LEE'S SUMMIT MISSOURI

DESIGN & CONSTRUCTION MANUAL DESIGN CRITERIA MODIFICATION REQUEST

PROJECT NAME: 100 NE Douglas

POST DEVELOPMENT DRAINAGE PLAN
SCALE: 1" = 10'

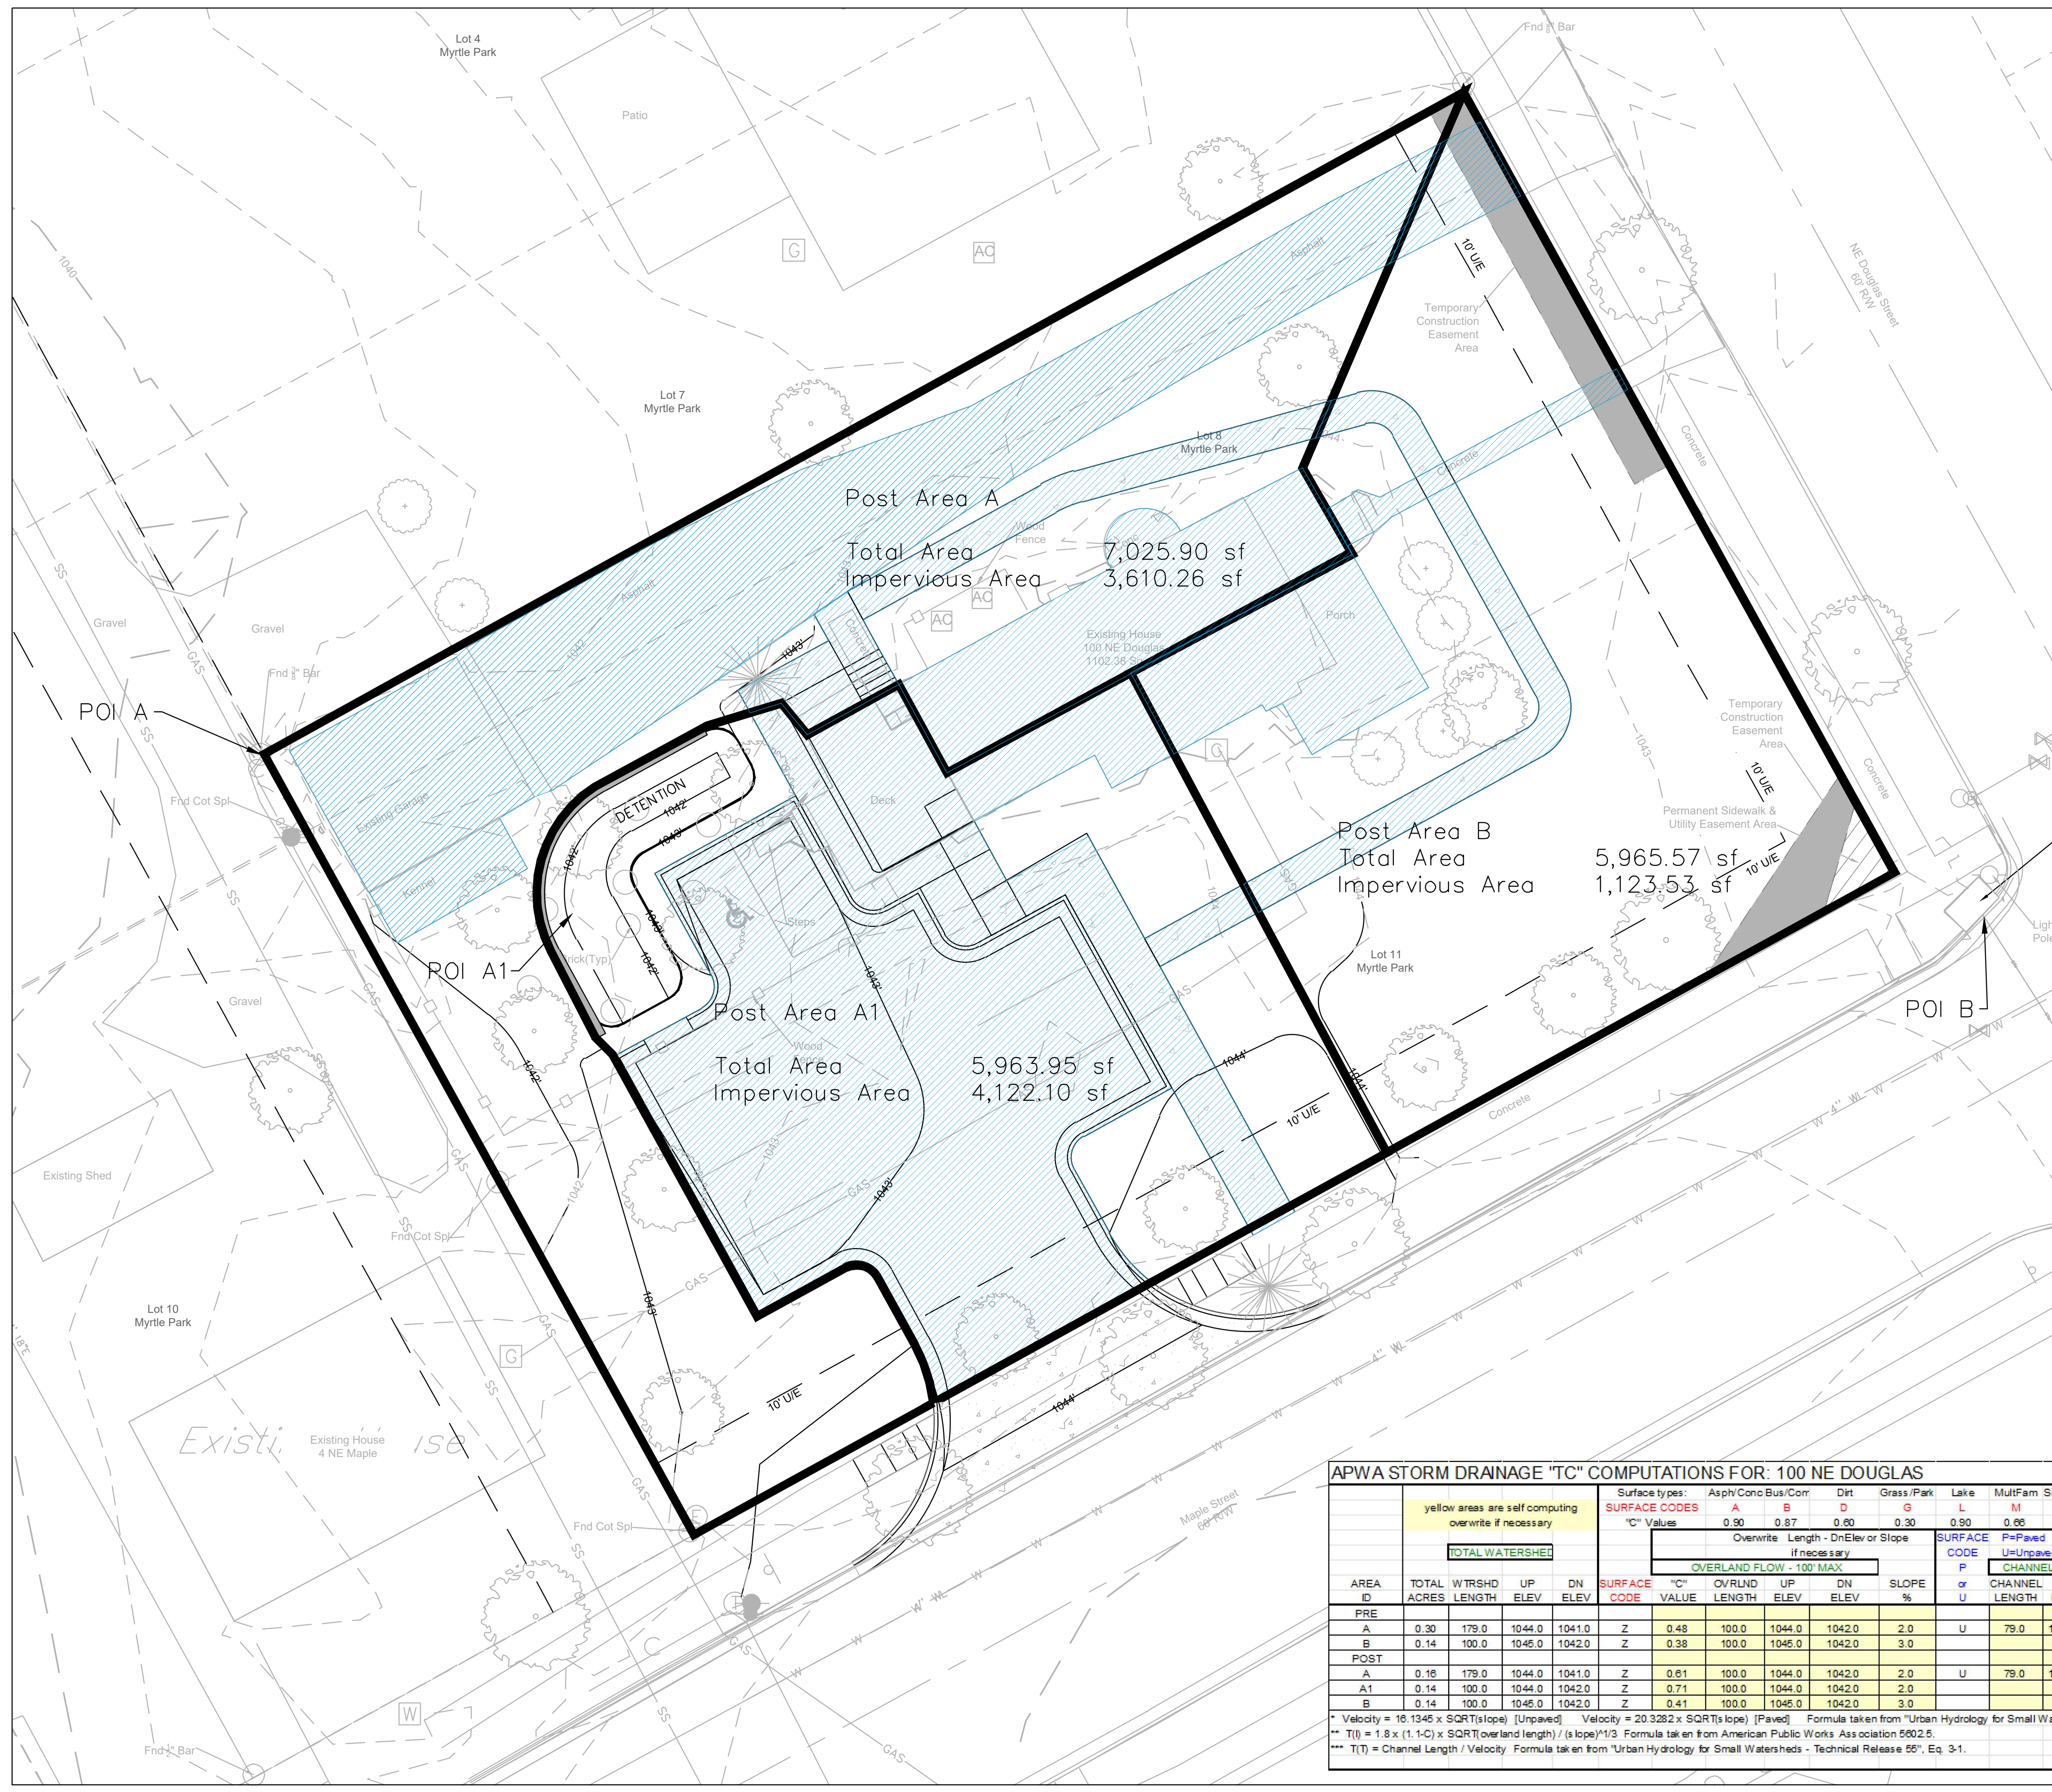
Peak discharge rates at POI A consisting of the Combined POI A Hydrograph (Sub-basin A + A1) will be reduced below Existing for all regulatory design storms. However, Allowable Peak Discharge Rates will not be met based on the sub-basin size, geometry and topography. It is not practical to convey runoff from certain parts of the unimproved tributary area to the infiltration basin.

The majority of the proposed improvements will be constructed in Sub-basin A1 where runoff traditionally drains via overland flow to the west property boundary. No concentrated flows will be released directly to any of the adjacent neighboring properties. The infiltration basin will release excess flows via a 50 lineal foot broad crested weir. Discharge will be released in a northwesterly direction via the proposed 90-degree weir helping minimize any potential impacts to surrounding properties. A consecutive 100-year storm would have a peak discharge of approximately 1.05 cfs across the 50' broad crested weir equating to 0.04' of depth at 0.52 fps.

The infiltration basin is designed to hold the 100-year storm volume. Infiltration was not figured in the reduction of proposed peak discharge rates but is being employed to provide water quality benefits. The infiltration basin design allows for any excess water not drained to percolate underground through clean rock into the surrounding soil minimizing if not eliminating any vector nuisances.

See Proposed Drainage Map attached on next Sheet.
